PLANNER'S REPORT

DATE: July 12, 2019
 TO: Tonya Hutson
 FROM: Lynn M. Patterson
 RE: **Design Review - 3210 Oakdale Road Addition**

The City of Hapeville has received a design review application from Ashok Avasthi for the addition of an upper-level sunroom to an existing single-family dwelling at 3210 Oakdale Road. The addition will use metal and glass panels attached to a raised wooden deck dividing the rear facade of the house into two levels.

REAR ELEVATION
SCALE: $\frac{1}{4}'' = 1'$

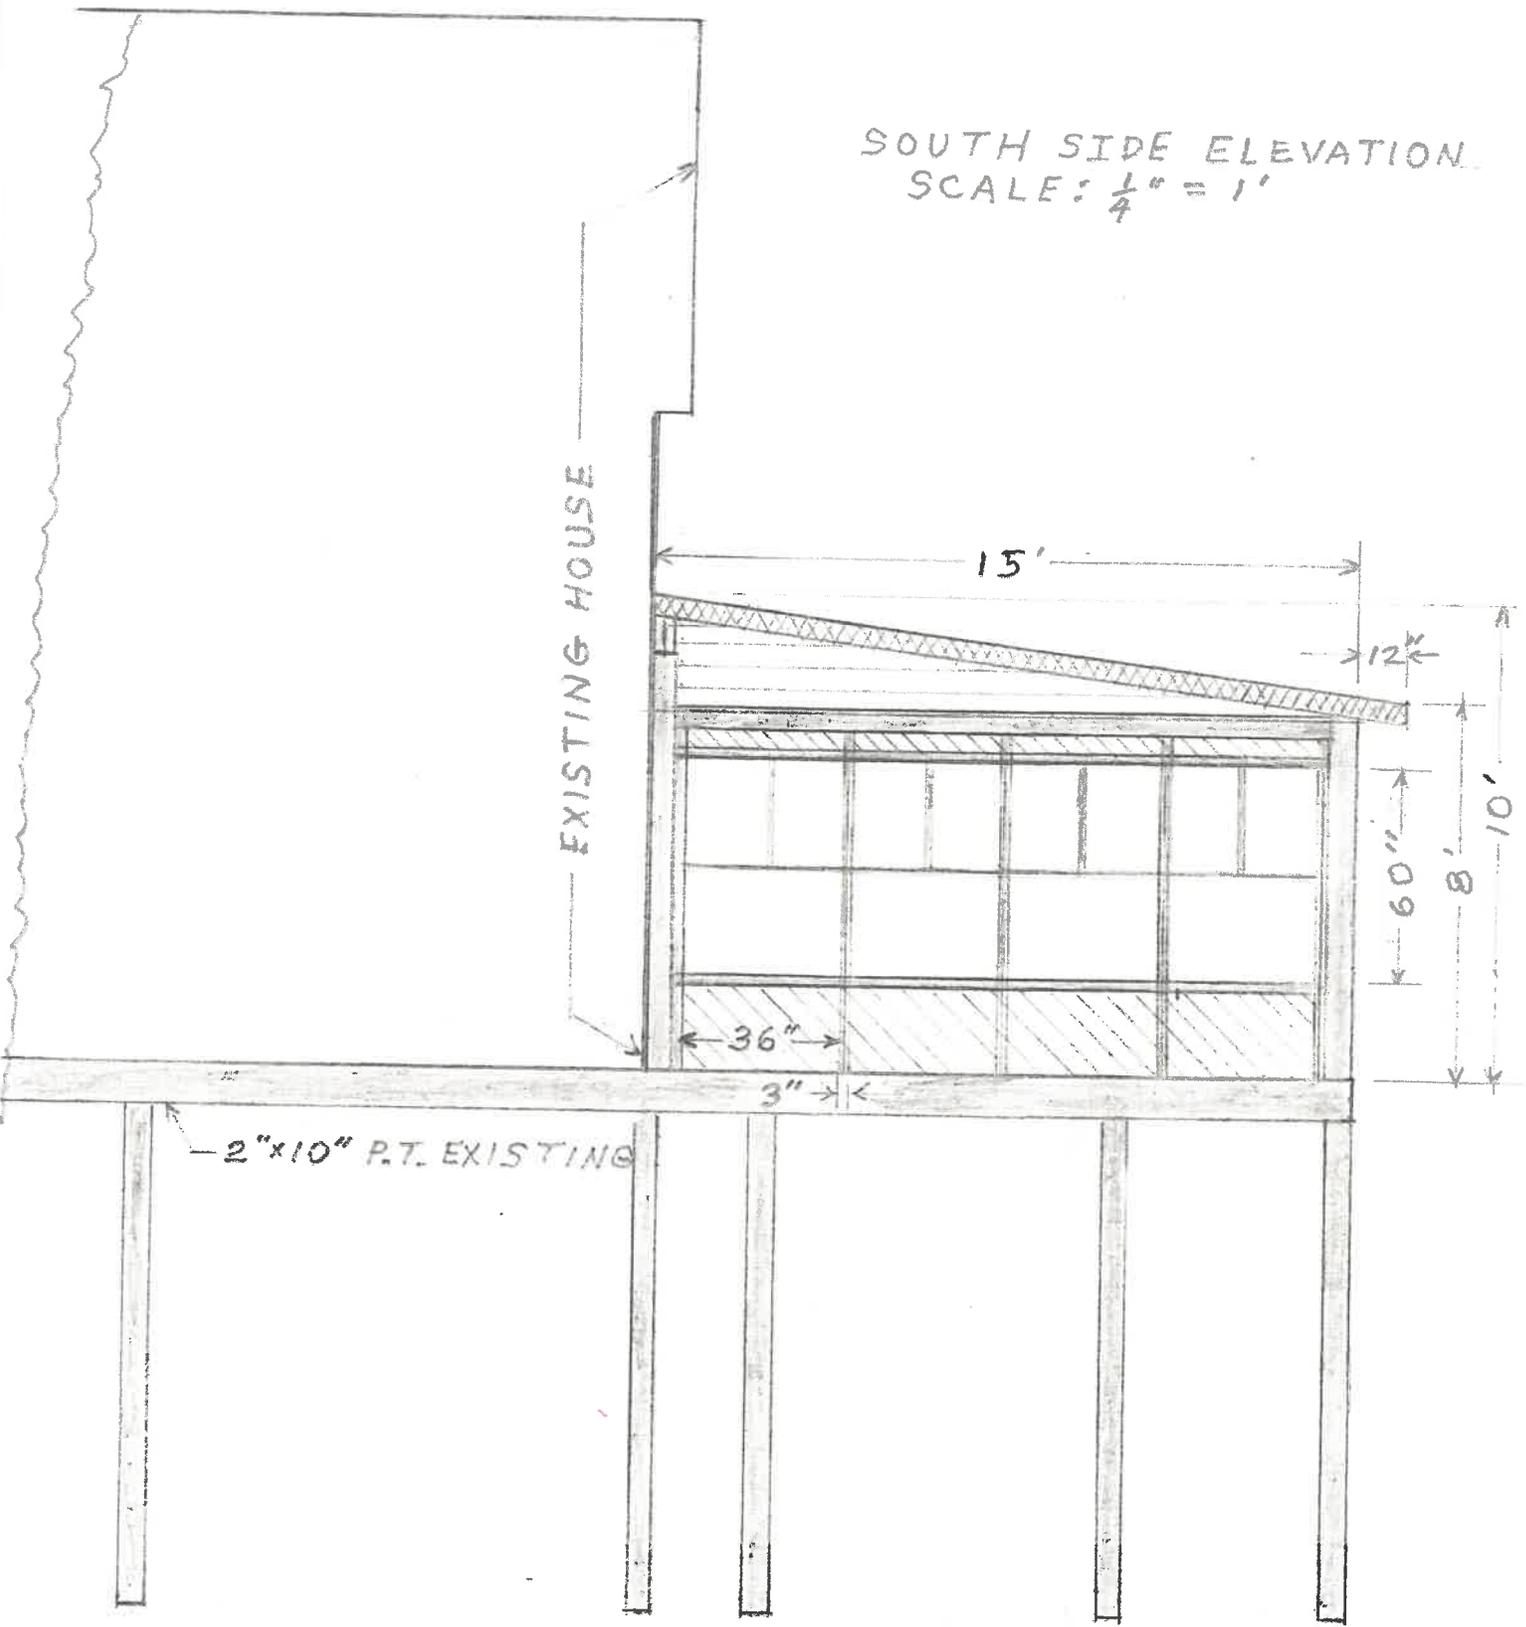
- STAFF COMMENT:**
- **The Applicant should clarify the roofing material for the proposed sunroom.**
 - **Proposed roof does not have gutters or downspouts.**
 - **Proposed roof is inconsistent with architectural style of existing dwelling.**

- **Scope of project does not include changes to street facing facade or existing style.**
- **Glass panels are not a permitted type of exterior building material.**

The proposed sunroom is to be constructed out of 3' wide glass panels held in place by 3", 5" and 6" posts which appear to be wooden. As such, this constitutes a glass curtain wall, which is not permitted. Further, the sloped roof made of insulated panels would be inconsistent with the roof of the existing building and lacks any gutters or downspouts and per the drawing, and the sunroom extends beyond the side of the residence.

As the drawings submitted are sketches provided by the applicant, the Design Review Committee may consider the proposed addition is constructed on top of a second story wooden deck. There has been no structural evaluation to determine if the deck is capable of supporting the proposed metal and glass window panels in addition to furniture and general activity.
